ANN ARBOR HISTORIC DISTRICT COMMISSION

Staff Report

ADDRESS: 515 S First Street, Application Number HDC23-0030

DISTRICT: Old West Side Historic District

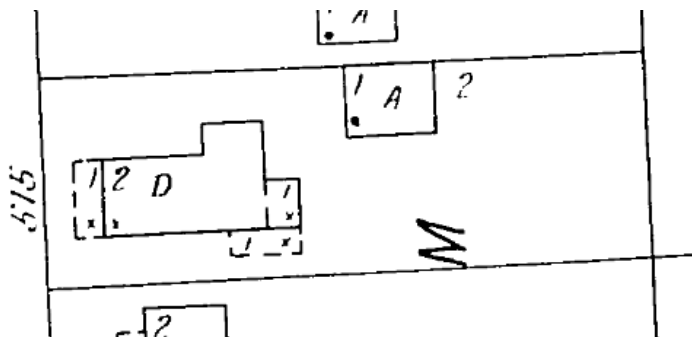
3. *Egress Window.* An egress window is indicated on the floorplan drawing, but not the elevation. Photographs provided do not show whether there is currently a basement window in this location (trash containers are in the way) but the location is appropriate. The foundation wall is fairly tall so there is plenty of room for an egress window, and it would be entirely out of sight from the public right of way. The well is constructed of pressure treated 4x4s with an interior ladder. The interior of the well is slightly larger than the required 36"x36" clear area. The window is not dimensioned but is a wood Jeld-Wen double-hung one-over-one. The depth of the well is not indicated.
